Wayzata Planning Commission

Meeting Agenda

Subject: Ovsyannikova Addition

Project Name: Meyer Place at Ferndale
Applicant: Homestead Partners, LLC
Property Owner: Meyer Properties
Addresses of Request: 105 Lake Street E
Prepared by: Jeff Thomson, Director of Planning and Building
“60 Day” Deadline: December 6, 2016

1 Site Plan

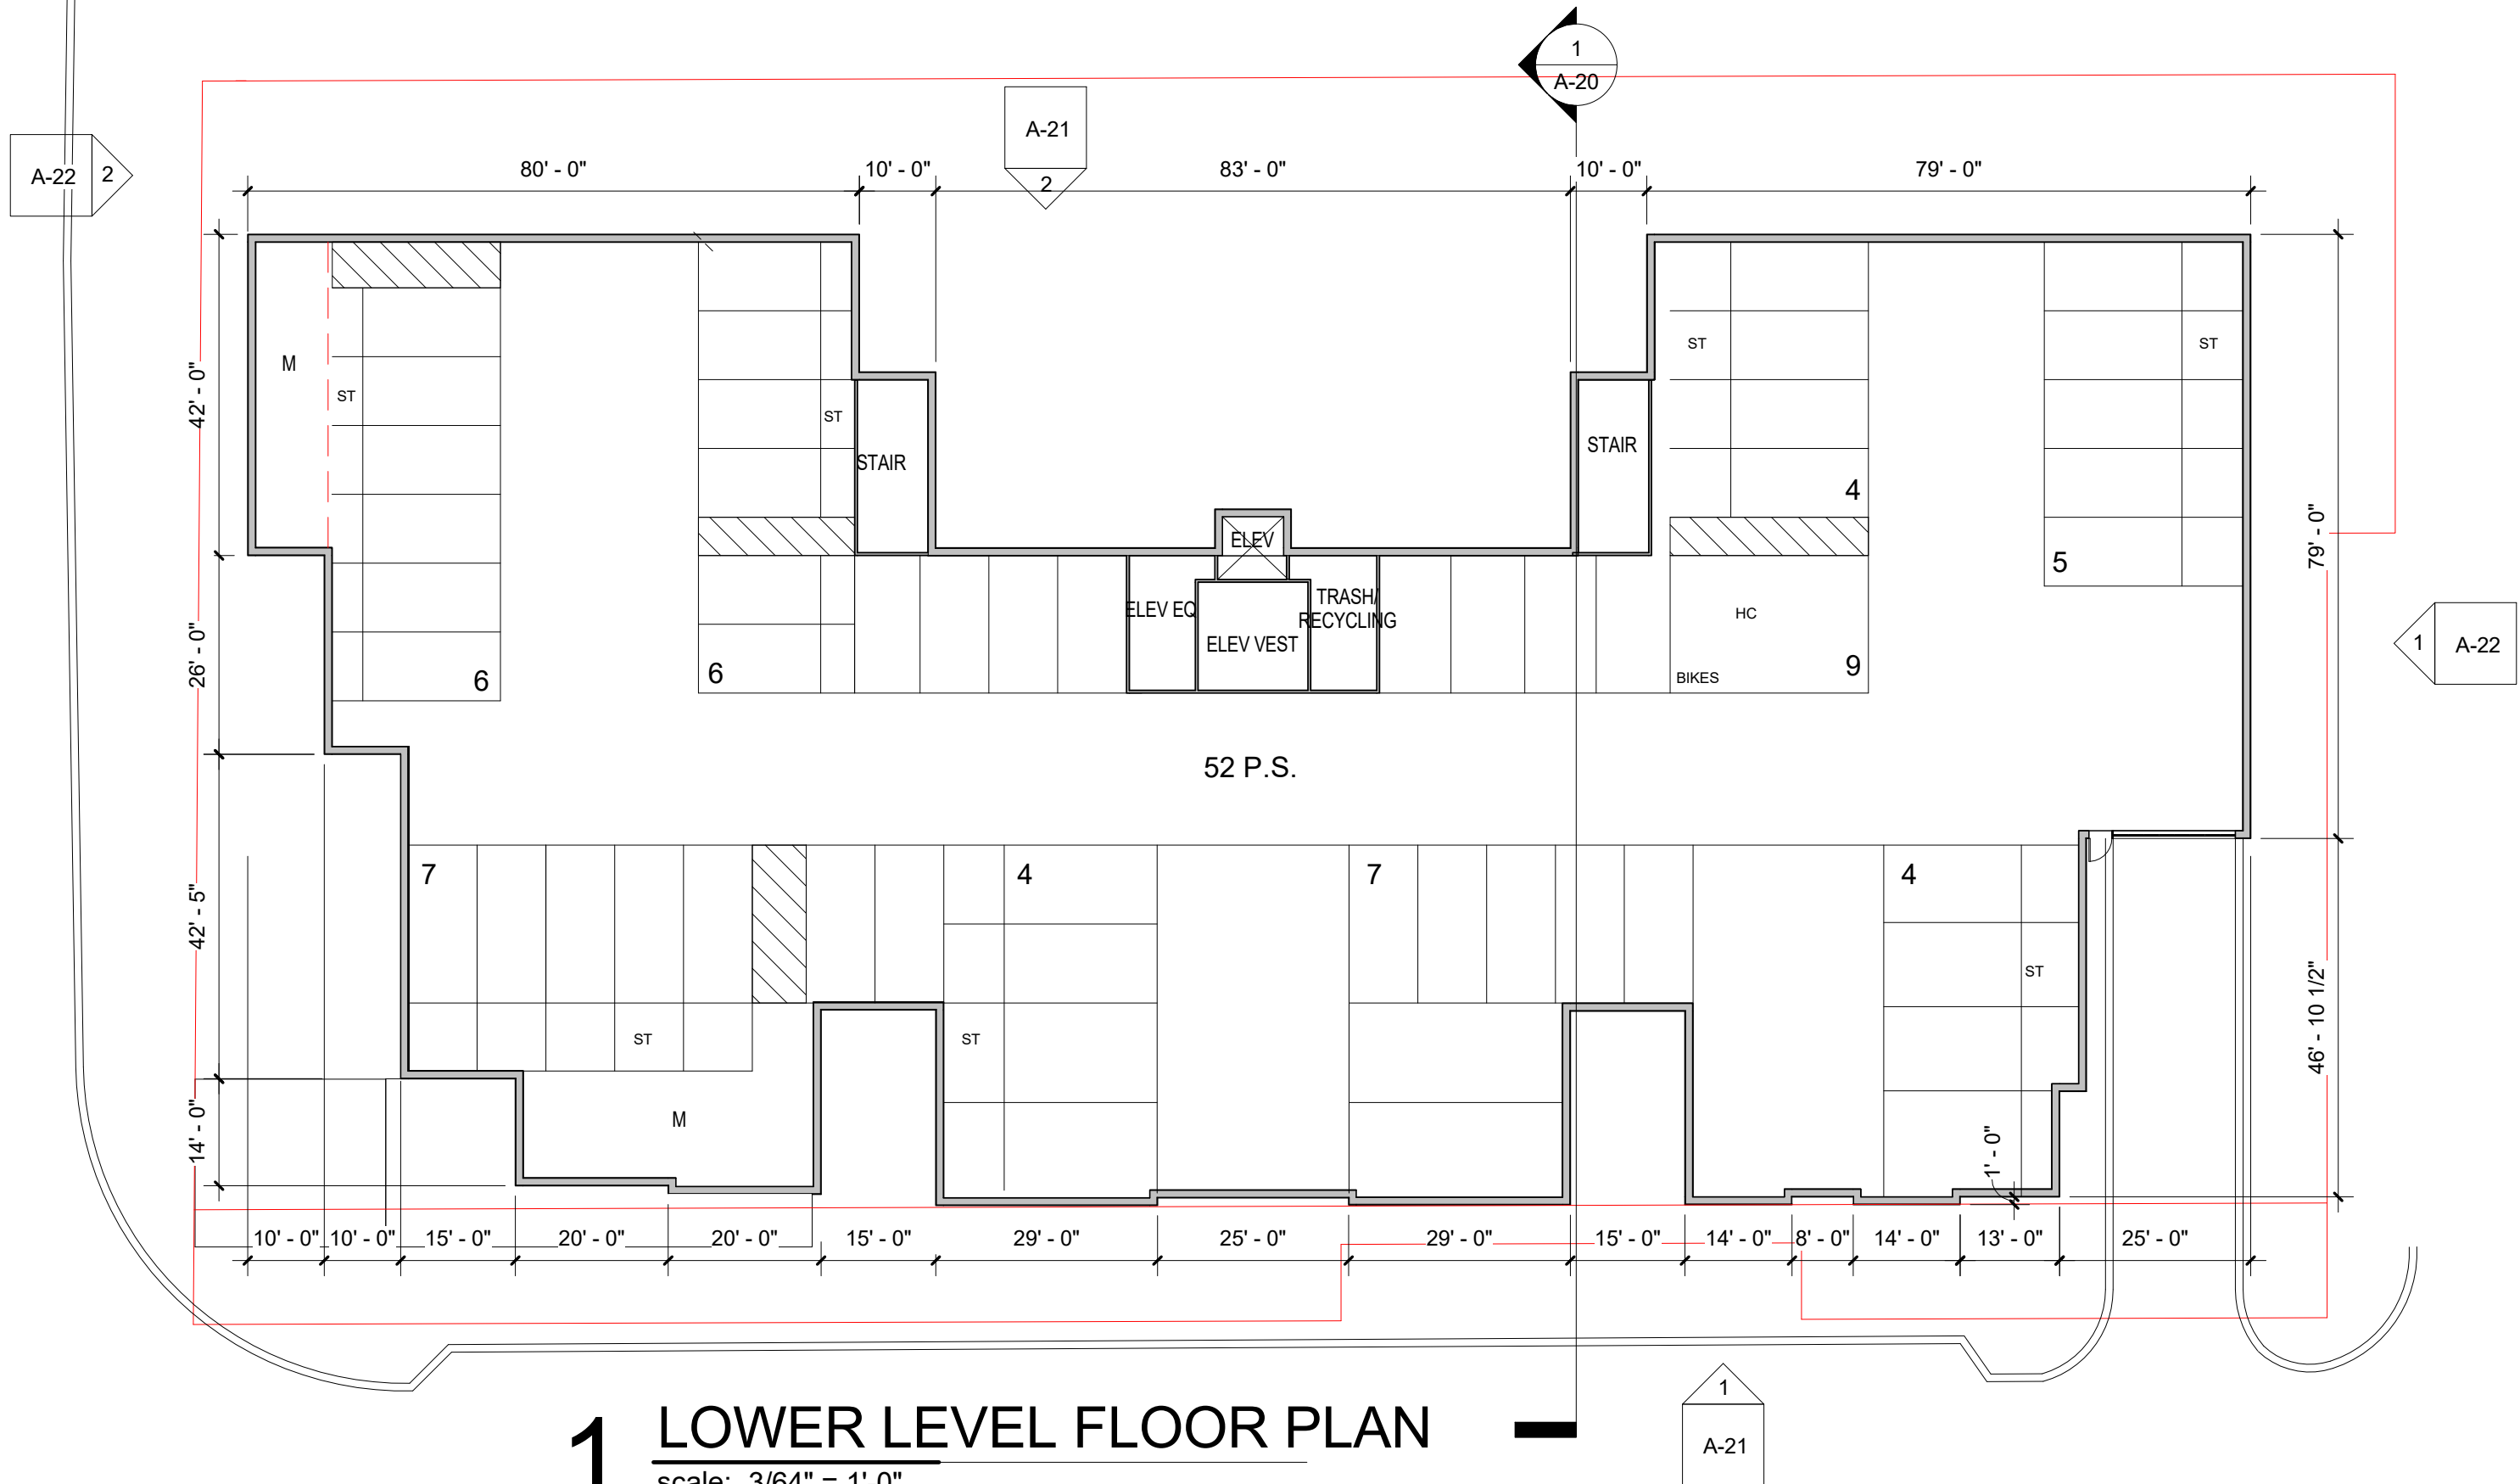
- Ferndale sidewalk: The proposed site plan includes a 12-foot wide sidewalk along Lake Street that would meet the design standards and the City's Lake Street sidewalk specifications. However, the Ferndale Road streetscape includes a 6-foot wide concrete sidewalk. The design standards require a sidewalk of at least 12 feet in width of exposes aggregate surface along all street frontages. There is not currently a sidewalk along either side of Ferndale Road that the proposed sidewalk could connect to. However, the Ferndale Road sidewalk would still require a deviation from the design standard.

Comments	Compliance
Walkways		
<u>801.09.13.1 – Lake Street District</u> A. Continuous sidewalks at least twelve (12) feet in width shall be provided along all public street frontages. B. Lighted sidewalks shall extend between rear and side parking areas and building entrances. All sidewalk lighting must project downward. C. Buildings with street frontage exceeding fifty (50) feet shall have at least one (1) bench. D. All sidewalk surfaces must match the exposed aggregate/brick accent sidewalks on Lake Street.	The proposed site plan includes a 12-foot Sidewalk along Lake Street that would meet the City's Lake Street sidewalk specifications of exposed aggregate surface with concrete accents. Two benches would be provided along Lake Street. The Ferndale Road street frontage includes adding a 6-foot wide concrete sidewalk with a landscaped boulevard with street trees between the road and the sidewalk.	Deviation Required. The streetscaping along Lake Street meets the requirements, but the sidewalk on Ferndale does not.

Profile View "110"

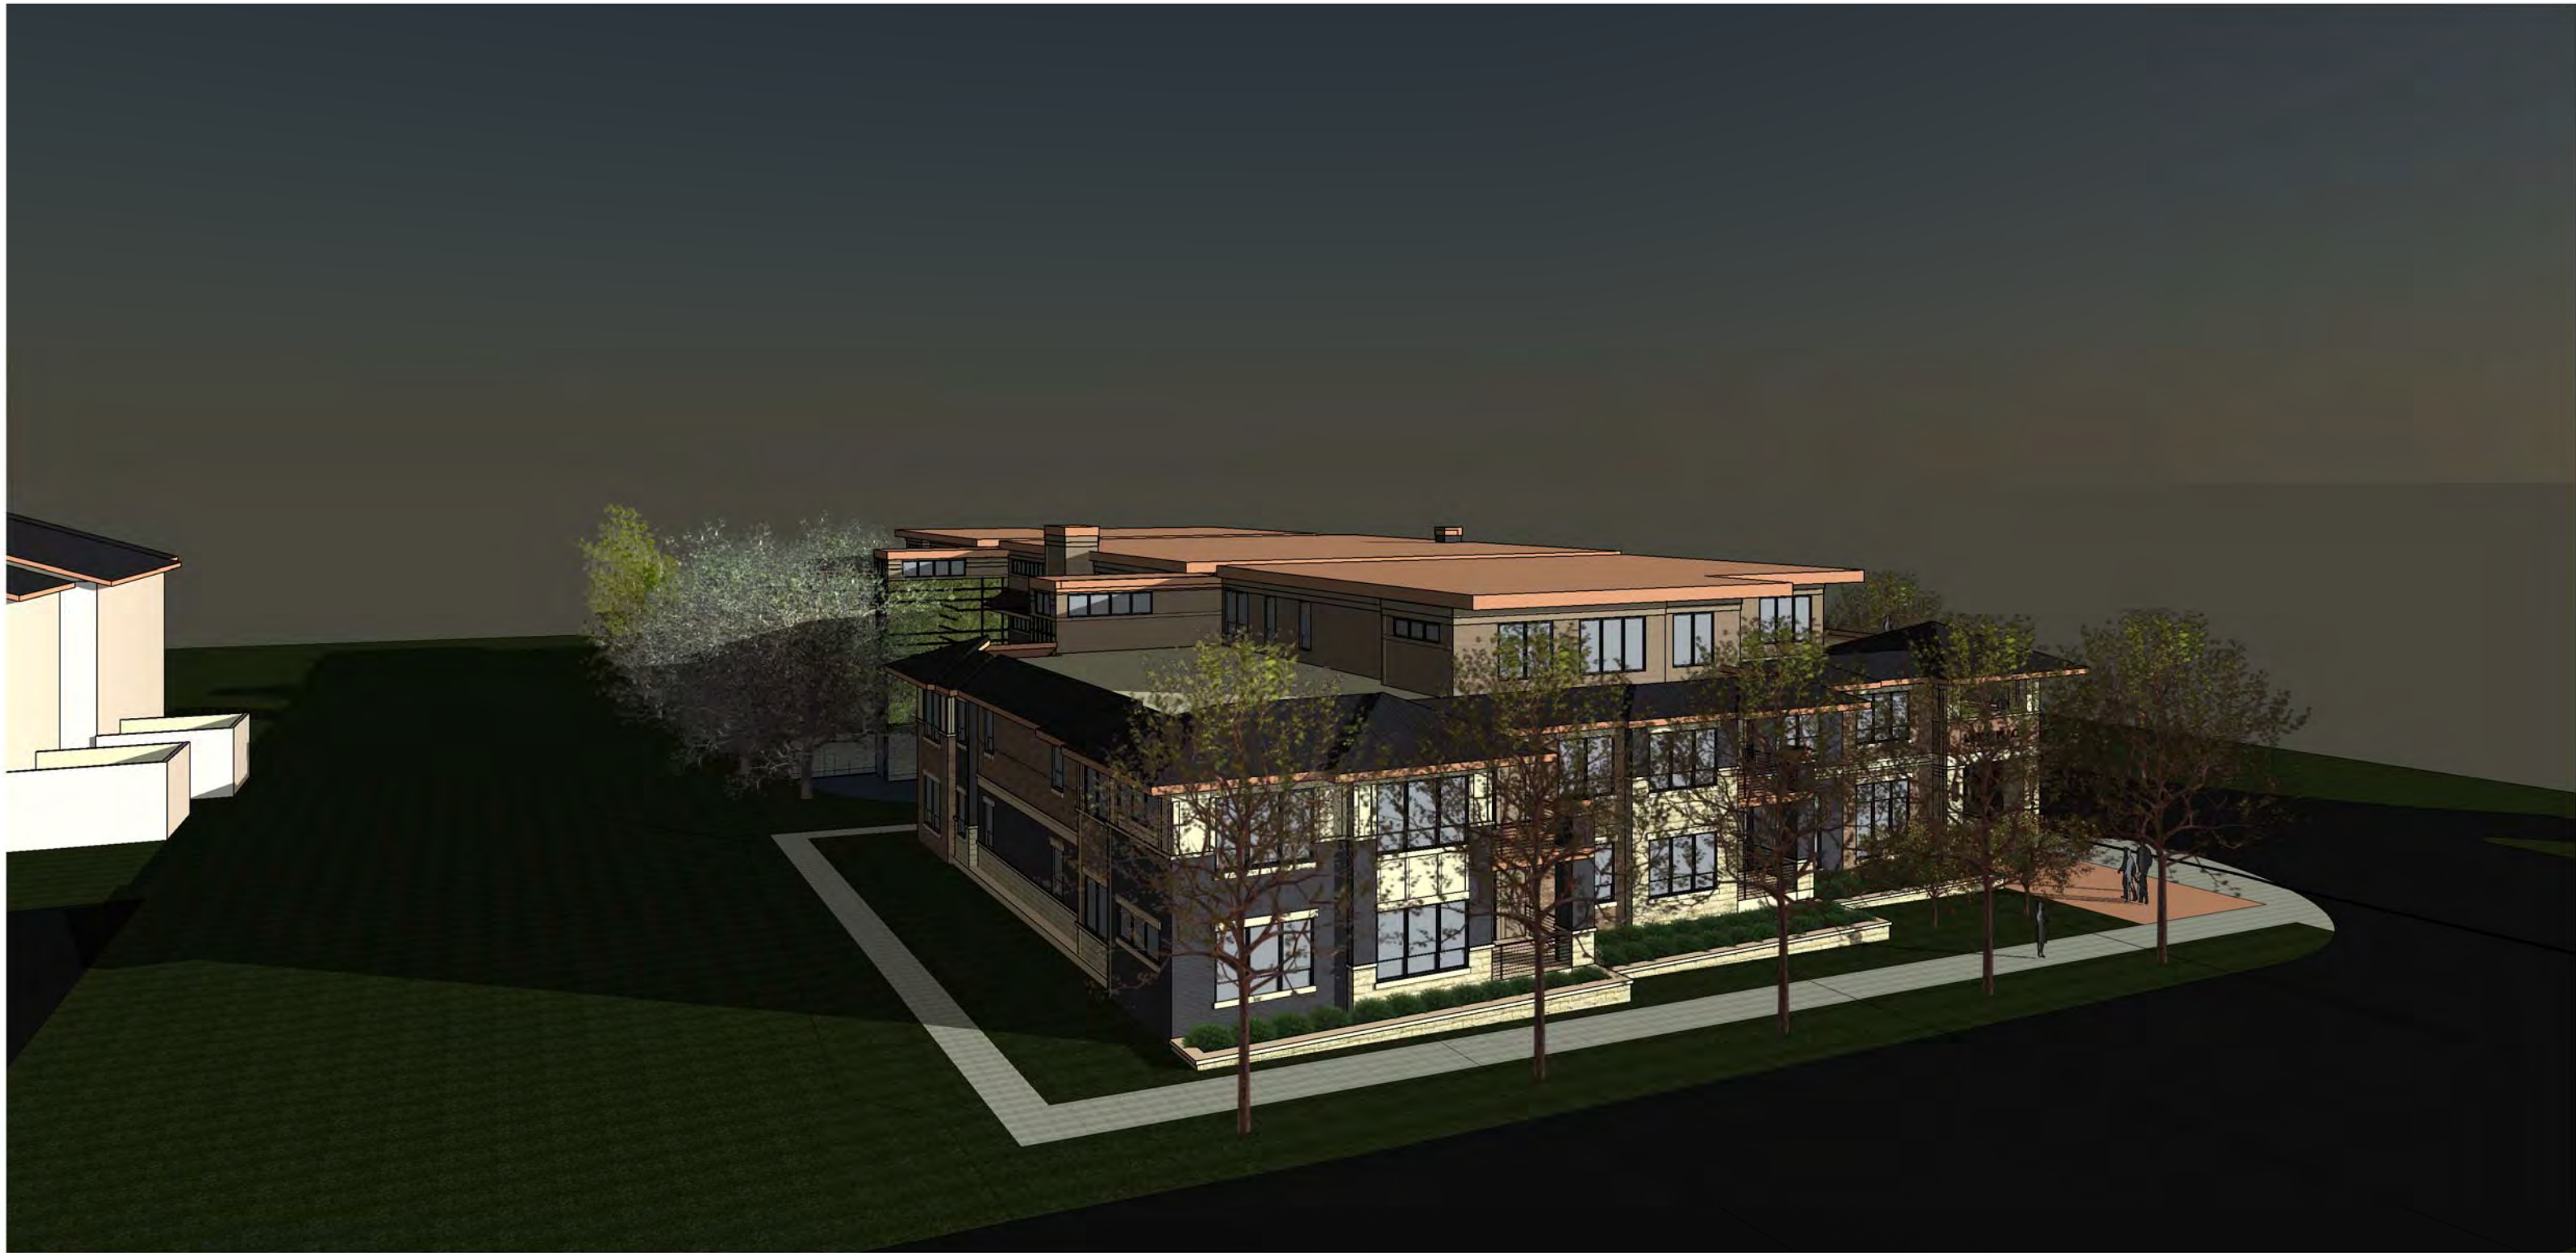
<u>801.09.5.1.C – All Districts – New Buildings</u> Wintertime sun orientation, solar access, and views of Lake Minnetonka are significant issues within the Design Districts. Building height should not negatively and significantly impact neighboring properties.	The proposed plans include a shadow study which shows the building would create minimal shading onto adjacent buildings. The plans also include a profile views of the proposed building as viewed from surrounding properties.	Yes
